Remarks Supporting Amendment

Responses to Examiner's Remarks in Detailed Action

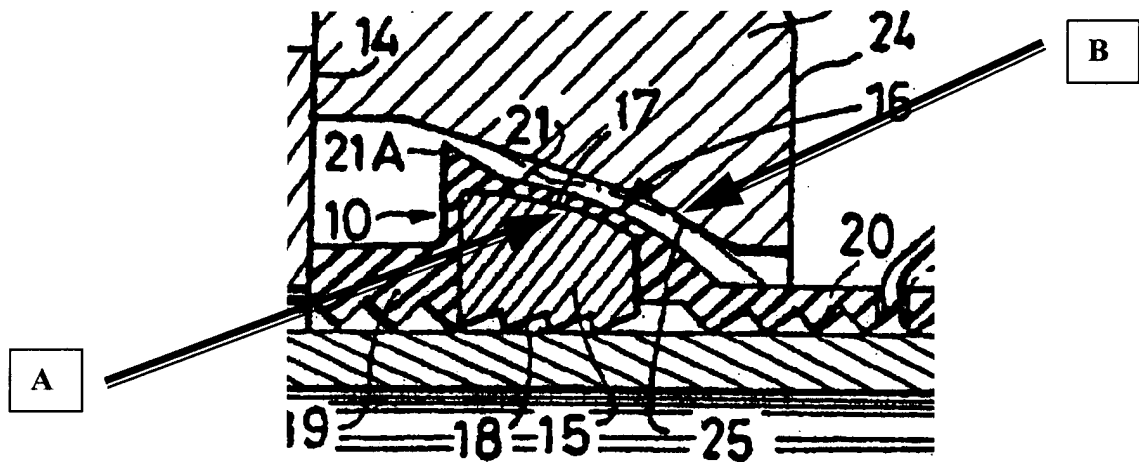
Reference to Figure 1 of Percebois, as cited by the Examiner, is instructive; Applicant reproduces a close-up of the relationship between the locking segment (Percebois 15, Applicant 1) as shown in Percebois Figure 1 below, with additional reference lines for clarity of discussion:

Reference line B points to the inside curved surface of Percebois' counterflange 11. Reference line A points to the outer convex face 17 of Percebois' locking member (referred to as an "insert 15" by Percebois). As can be seen from the above image, upon extractive movement of the male end from the female end (e.g., movement of the inserted pipe toward the right), Percebois' locking member will also move right until A contacts B. It is evident that the convex shape of A is complimentary to the concave shape of B, meaning that A and B will mate. No opportunity is provided for pivoting of the locking member.

Moreover, reference to Percebois' Figure 1 itself indicates that pivoting is not *possible* in this relationship. The tight match between the configuration of A and B will ensure that pivoting does not occur. Percebois notes at Column 6, lines 2 through 9, that inserts 15 press against the counterflange "without play" (line 4).

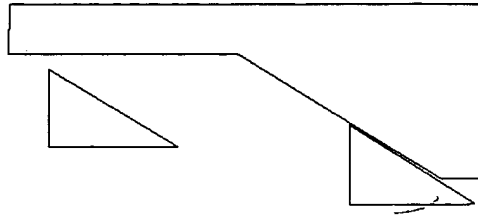
Notably, those in the art will understand that Percebois is depicting a known locking mechanism for push-on joints is the "sliding wedge." In a sliding wedge configuration, the locking segment is configured with a surface that slidably mates with a longitudinally resistive surface, as shown below:

In the above image, as the triangle, shown first as positioned to the far left, moves to the right, its slanted face will mate with the conversely slanted face of the large polygon. Once such face to face contact is made, the triangle will not pivot, but will be urged downward for every unit of movement made toward the right. This type of sliding wedge movement is commonly known in the pipes and appurtenances industry. Because of this industry background, persons reasonably skilled in the art would interpret Percebois' Figure 1 as involving just such a mechanism. This understanding is demonstrated correct by Percebois' discussion of the "backward" movement of the insert at Column 3, lines 50 – 66 and Column 4, lines 23 - 34.

Claim 13-15 – Percebois does not show a gasket and segment adapted to fit within the female end of a pipe.

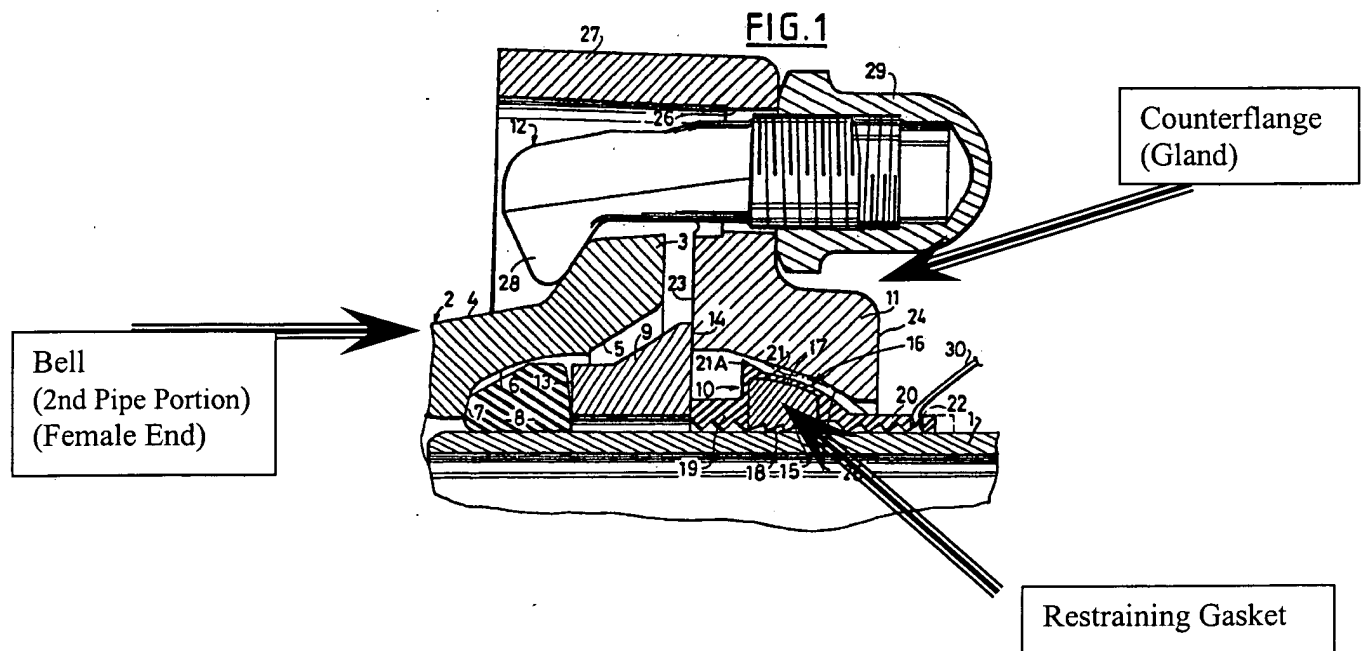
Claim 13 recites that the restraining gasket, along with its embedded locking segment, is “adapted to fit within a bell end of a second pipe length.” (e.g., the segment is in the bell of the female end) The Examiner’s assertion that Percebois demonstrates a gasket “adapted to fit within a bell end of a second pipe length 2,” (Office Action at p.7, line 9) is not in accord with Figure 1 of Percebois, upon which the Examiner relies. Figure 1 is reproduced below for clarity. Percebois defines pipe length 2 as the female end, or bell, of the juncture. See, Percebois 2:24-25. Percebois’s item 11 is a counter-flange, and not part of the bell at all. See Percebois, at Abstract and 3:10-30. As is evident by viewing the reproduction of Figure 1 below, the retaining gasket of Percebois fits within the counterflange (termed “gland” by Applicant); it does not assemble within Percebois’ bell end 2.

Percebois thus does not show the same arrangement of elements as recited in the claim. Percebois therefore fails the requirement of MPEP 2131 that the "elements must be arranged as required by the claim... In re Bond..." The rejection accordingly fails to set forth a defensible prima facie case of unpatentability, and must be withdrawn.
